Oakson A Federal 2
30-005-20617
BLM
May 12, 2023
Conditions of Approval

Plug And Abandonment Procedure

OAKSON A FEDERAL #002

Oakson A Federal #002 NMOCD COAs

Proposed Wellbore Diagram

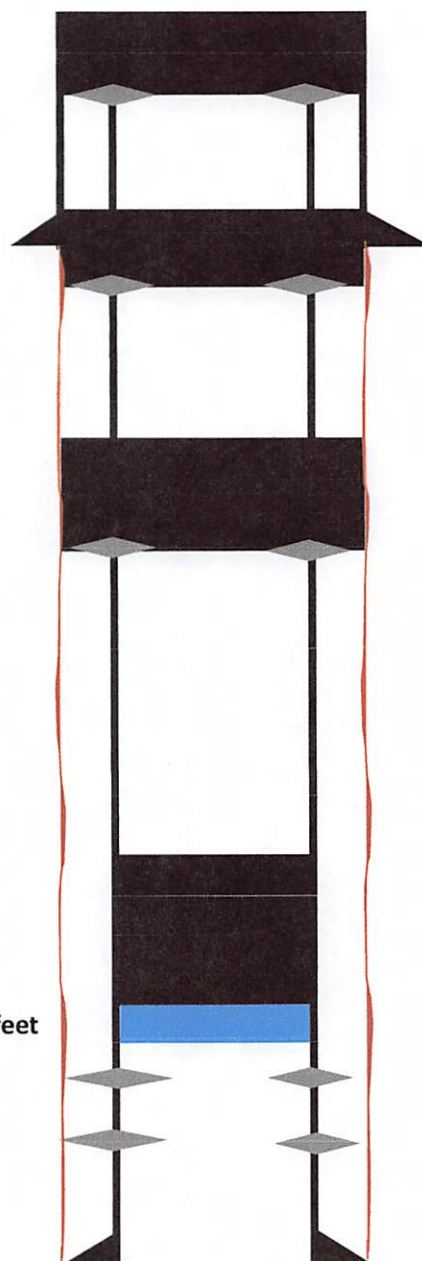
1. The first cement retainer depth as proposed in the NOI from BLM will be changed from 3848' to 3788'.
2. A CBL will be run from the retainer at 3788' to surface. The log distribution listed on the Drake procedure is to be changed as follows; remove Brandon Powell; add Gilbert Cordero, gilbert.cordero@emnrd.nm.gov, Loren Diede, loren.diede@emnrd.nm.gov and Jennifer Sanchez, j1sanchez@blm.gov.
3. Add cement plug for the Grayburg and Queen formation tops. My formation top picks are 2714' for the Grayburg and 2565' for the Queen. Add a cement plug to cover Grayburg/Queen formation tops from 2764' to 2515', CBL will determine if plug is to be inside or inside/outside. (plus appropriate excess volumes).
4. This email is to be attached to any subsequent P&A sundries for this well.
